# Host, module, and test fixture illustrations for Annex 176D

Adee Ran, Cisco

# Proposed modification – Figure 176D–2

Figure 176D–2—200 Gb/s per lane AUI-C2M link diagram

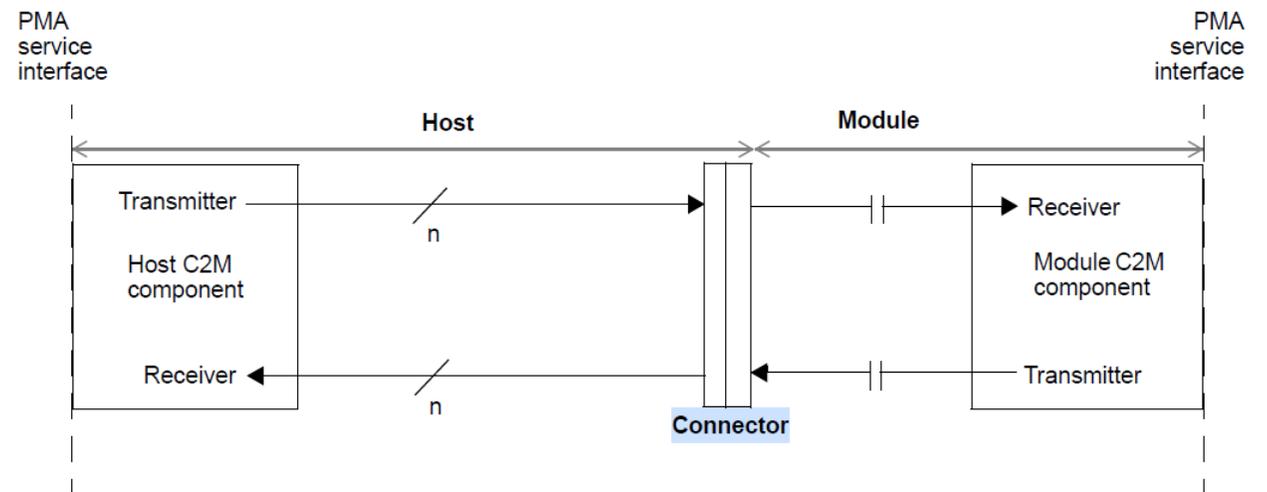
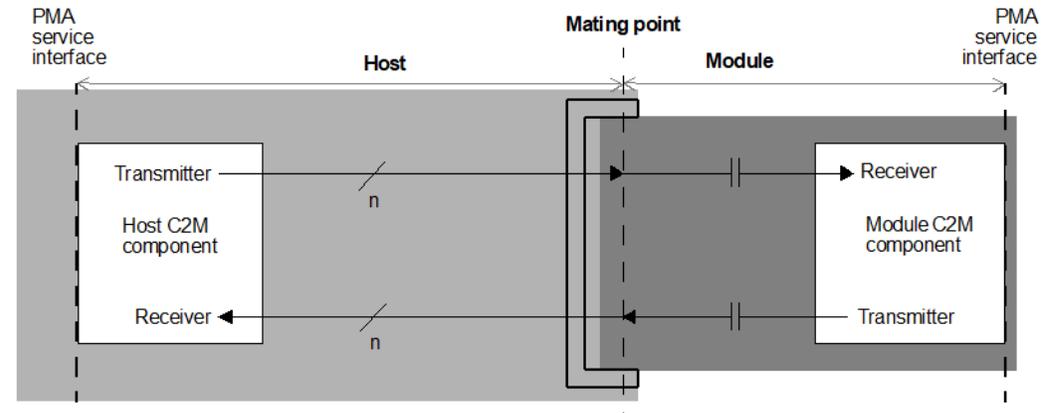
- During Working Group ballot there was a multitude of comments related to the illustrations of modules, hosts, text fixtures, especially on the “connector” label in multiple figures. The figures and notes went through multiple changes.
- Recently comment #57 against D2.3 noted inconsistency between figures, and lack of clarity of what the vertical line in the “connector” represents.

- The word “connector” is ambiguous
  - In dictionary.ieee.org - in IEEE Std 1680.1-2018 as "An electrical or mechanical coupling device employed to connect one element with those of another element"
  - In SFF-TA-1045 (pertinent for this annex): "Each half of an interface that, when joined together, establish electrical contact and mechanical retention between two components. In this specification, the term connector does not apply to any specific gender; it is used to describe the receptacle, the plug or the card edge, or the union of receptacle to plug or card edge. Other common terms include: connector interface, mating interface, and separable interface."
- Outside of figures, it only appears in the Annex once – in 176D.8.3 (ERL)
  - “...the first discontinuity of the AUI-C2M connector“
- Unclear terminology should be minimized

- Annex 176D does not specify any “connector”...
  - But it refers to Annex 179B for test fixtures, which are associated with “MDI connectors” – implicitly this means the same connectors.
  - In practice, hosts use the MDI receptacles of Annex 179C, and modules plug into them. There has been no discussion of other C2M connectivity in P802.3dj.
- The vertical line in the “connector” seems to represent the mating point, which is all we care about.
- The current figures are a mixture of block diagrams with electrical components and mechanical “hints”.
  - Many readers know how modules and hosts look like and how they connect – but the figures are far from being representative.
  - The proposed new figures are not mechanical drawings but should be more representative and clear.

NOTE 1—The number of lanes n is 1 for 200GAUI-1, 2 for 400GAUI-2, 4 for 800 GAUI-4, and 8 for 1.6TAUI-8.

NOTE 2—The host is depicted as having a receptacle into which the module is plugged. This is based on the MDI connectors specified in Annex 179C. Other connection methods may be used.

New note points explicitly to Annex 179C

Figure 176D–4—Host compliance points

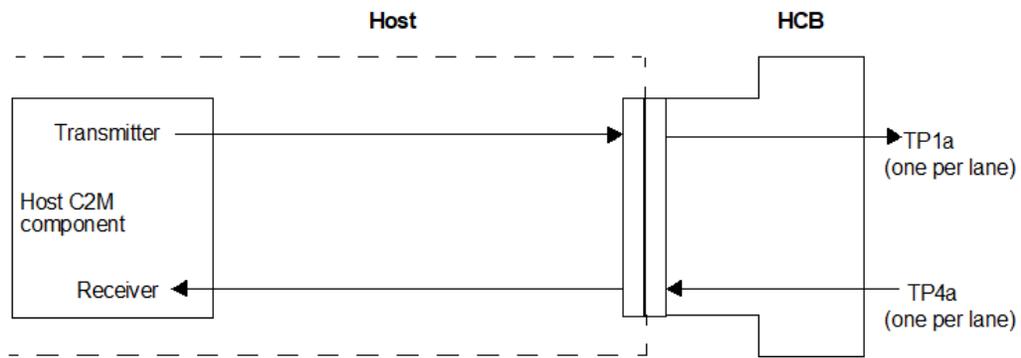
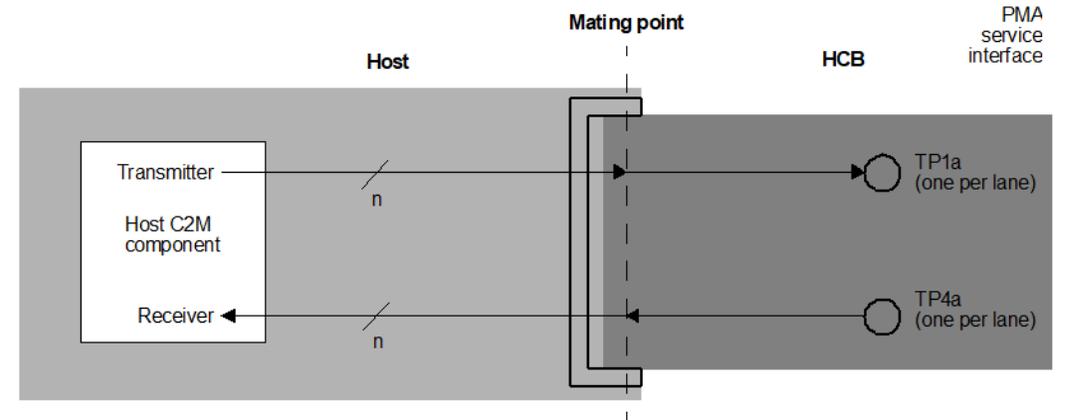
# Proposed modification – Figure 176D–4

Figure 176D–5—Module compliance points

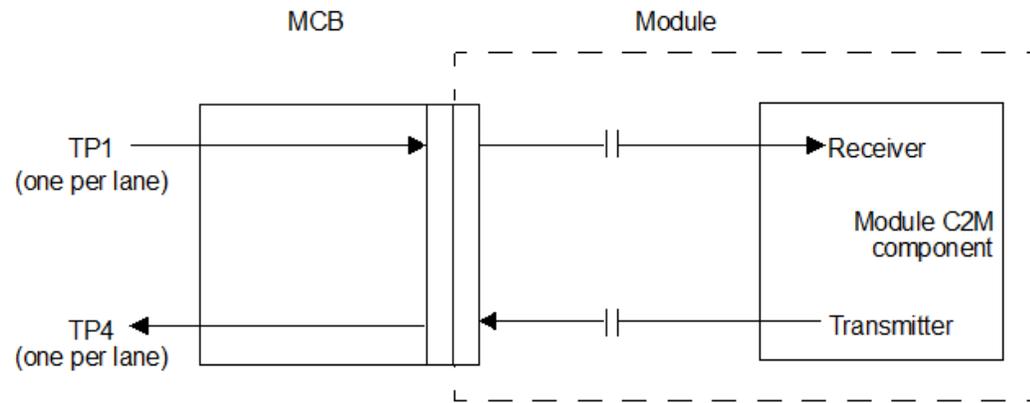
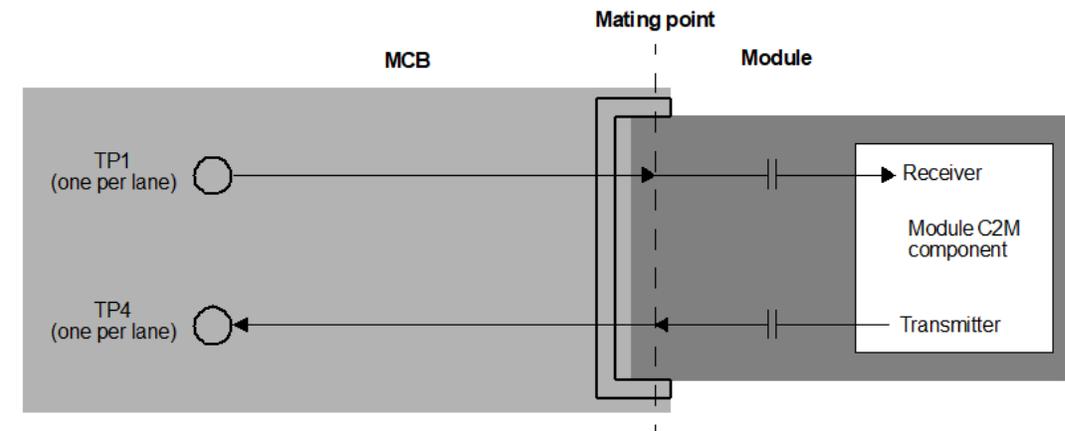
# Proposed modification – Figure 176D–5

**Figure 176D–6—Reference insertion loss budget at 53.125 GHz**

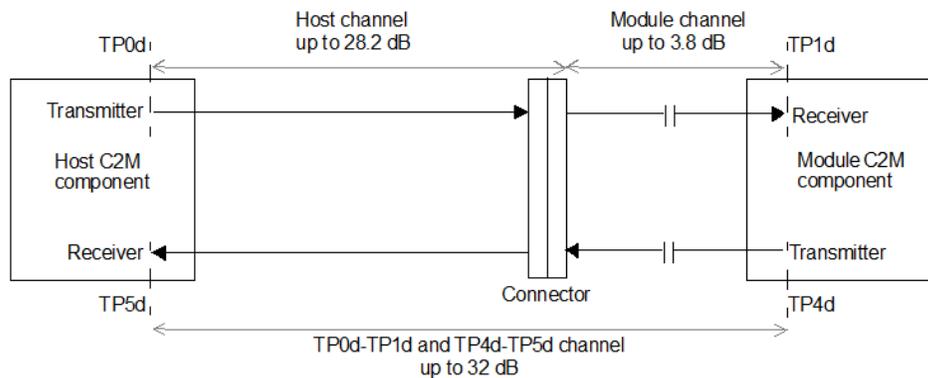
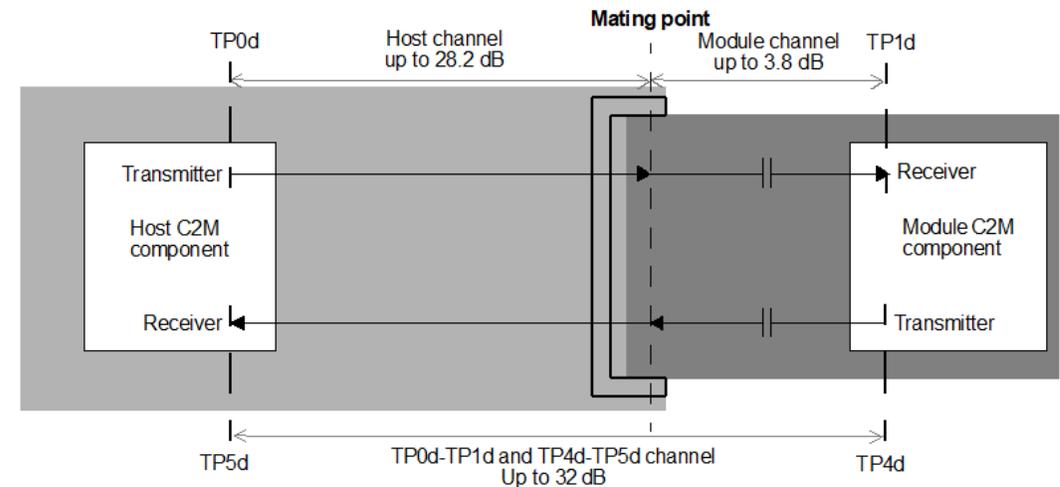
# Proposed modification – Figure 176D–6

NOTE—For loss budgeting purposes, the host channel loss is from TP0d to the center of the edge connector of the module.

The note in the existing figure is not needed anymore – it is evident in the new figure.
